*Proceedings of the Madras Government, Public Works Department,
5th July 1876. No. 1,701.*

CIVIL WORKS, No. 5-A.

Name of Work.—Constructing forty-five Native Constables' huts, and four Native Head Constables' huts near the Central Jail at Salem.

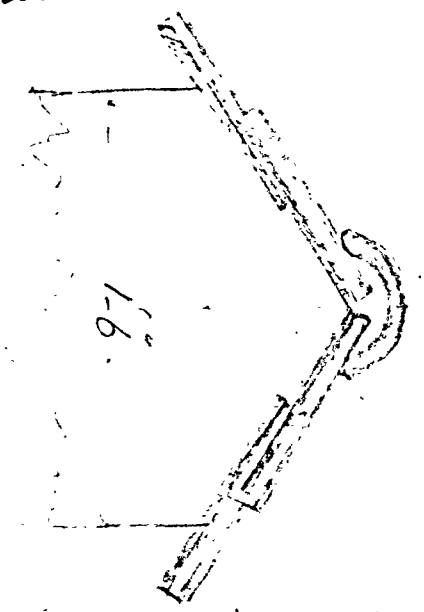
No district has submitted data
 for tile casing but has
 been made which shows
 100 tiles to be required
 Bottom Rows due side 44 tiles (5x9)
 bottom sides 28 - covering tiles 32
 to the filler - 64 - Ridge - 8 tiles
 (4 extra on each side allowed for the priming
 with wash work to water be)

Large power tiles addition
 for 1 1/2 in 28 tiles
 Due to the tiles 64 - do
 Ridge - 8 do
 100 tiles
